APPENDIX B
: INFORMATION OF CLASS II PERMISSIVE CHANGE

Information of Class II Permissive Change

EUT Type: Household Refrigerator
Model Name: SKSCF1801P
FCC ID.: BEJE09MFE07
Applicant: LG Electronics USA, Inc.

2. Contents of change(s): Alternated Item.

< PCB Assembly Main > : **P/No. : EAX67566001 Or EAX67566005**

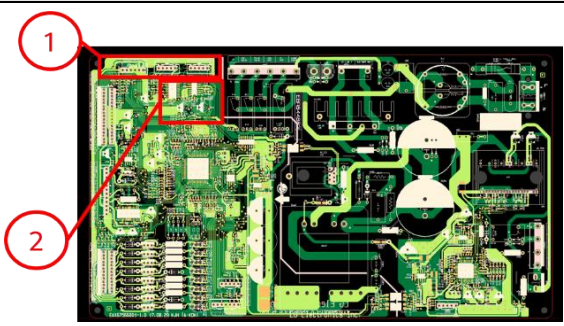
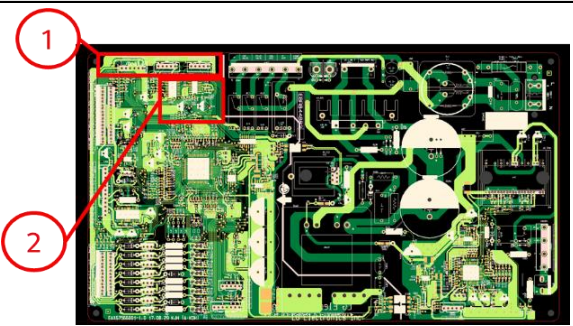
OLD	NEW
PCB Artwork	 <div data-bbox="367 862 742 1030" style="border: 1px solid black; padding: 5px; margin-top: 10px;"><p>① Change Connector ② Add DC Boost circuit</p></div>	 <p style="text-align: center;">Or</p>
